ACCESSION NBR:8004010330 DOC.DATE: 80/03/19 NOTARIZED: YES DOCKET #
 FACIL:50-220 Nine Mile Point Nuclear Station, Unit 1, Niagara Powe 05000220
 AUTH.NAME: AUTHOR AFFILIATION
 DISE,D.P. Niagara Mohawk Power Corp.
 RECIP.NAME: RECIPIENT AFFILIATION
 EISENHUT,D.G. Division of Operating Reactors

SUBJECT: Forwards info re primary coolant pressure isolation capability as per 800223 request. Info demonstrates that continued operation of facility does not present undue safety hazard to public.

Re: Nine Mile Point Unit 1
Docket No. 50-220
DPR-63

WASH-1400, EVENT V
(LOSS OF PRESSURE ISOLATION)

PROTECTIVE SYSTEM TYPICAL SENSOR ARRANGEMENT

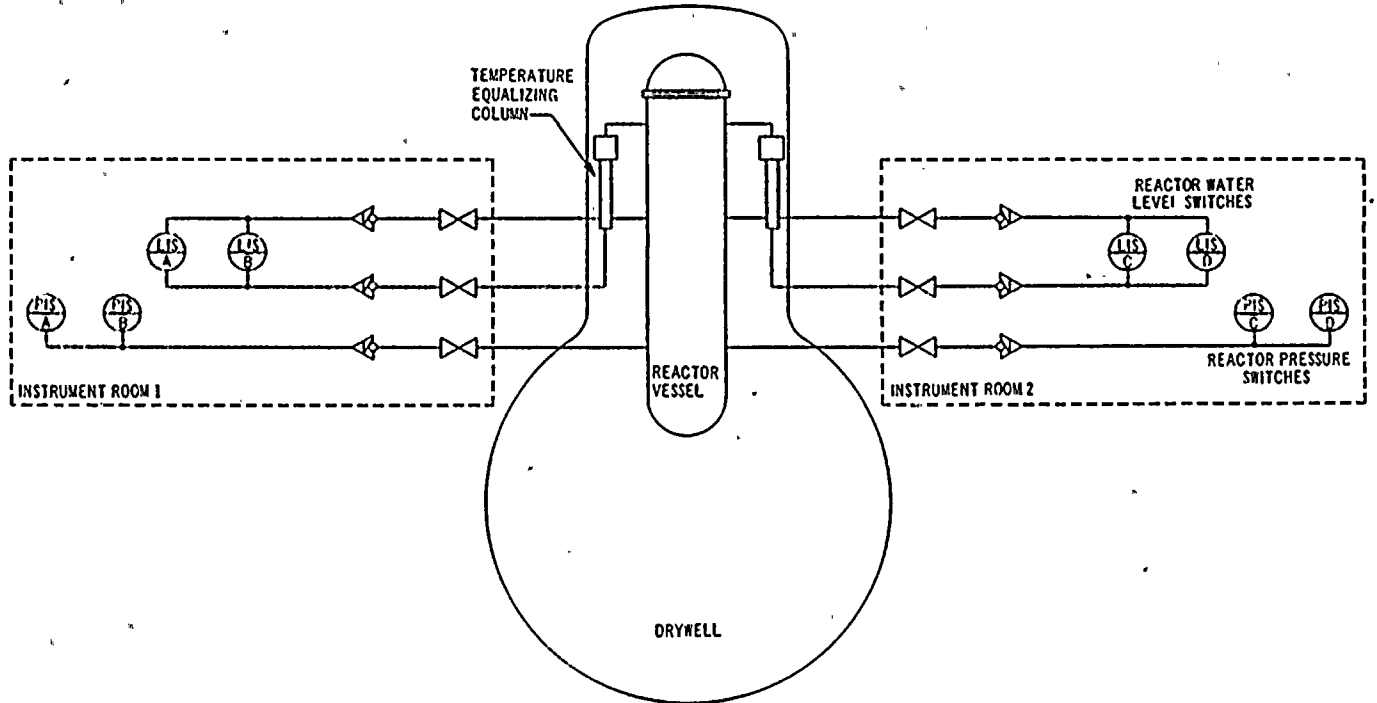
The entire reactor instrumentation system is designed for reactor pressure. In addition, flow checks are used. This would limit flow to less than the makeup capability of the control rod drive pumps.

NUCLEAR STEAM SYSTEM
 FIGURE OP-1-1
 9-1-75

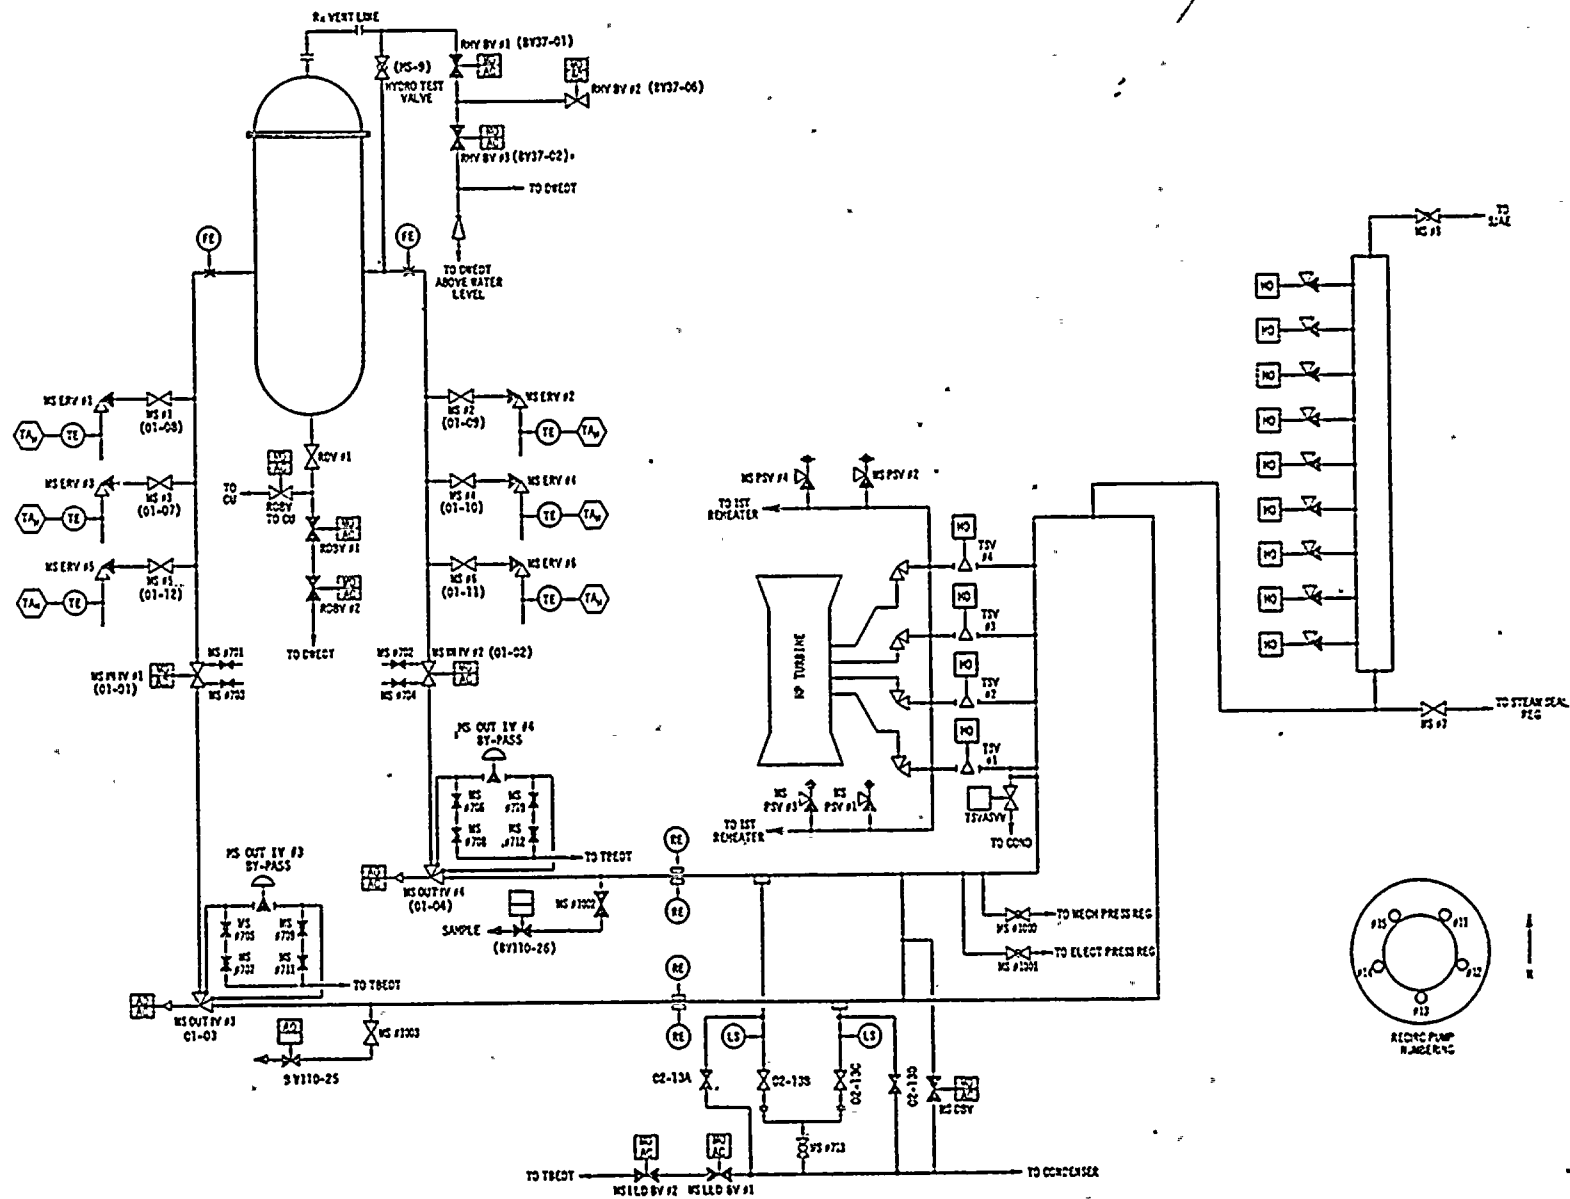
The main steam system is designed for reactor pressure up to the high pressure turbine. Two check valves in series are not relied upon in this system.
